Comment to the proposed rule on the *AP1000 Design Certification Amendment* Docket ID NRC-2010-0131 As noticed in the Federal Register on February 24, 2011

> Report Prepared for Friends of the Earth By Chief Engineer Arnie Gundersen Fairewinds Associates, Inc May 10, 2011

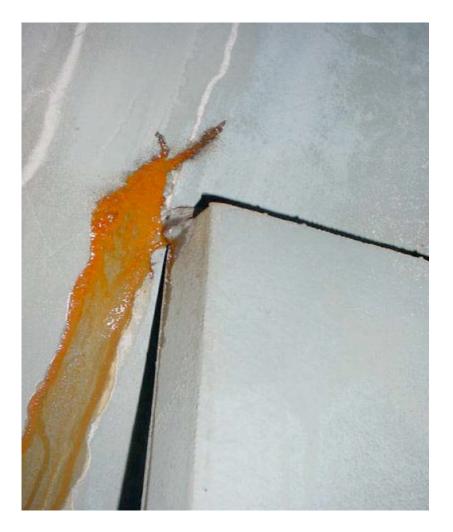
On June 28, 2010, three days after the ACRS meeting, Fairewinds Associates, Inc informed the ACRS of *yet another containment failure*, this time at the Fitzpatrick nuclear power plant in 2005. The photo below of the 4 ¹/₂" crack was taken in 2005 from the outside of the containment torus at the Fitzpatrick nuclear power plant in Oswego, NY.

and found that the Fitzpatrick nuclear power plant developed a large though-wall leak that was not due to corrosion. Once again, here is a unique violation of the BWR containment system that is directly applicable to the Westinghouse design of the AP1000.

The Fitzpatrick crack is due to differential expansion in a thick containment that is of similar thickness to the proposed AP1000 design and like the cracks previously uncovered at Hatch 1 and Hatch 2. Thus to date, three thick containment systems have experienced complete through-wall failures that remained undetectable by ASME visual techniques until each through-wall crack actually appeared. Similar stresses resulting in cracks could also occur in an AP1000 nuclear power plant if it is constructed to the current inadequate specifications.
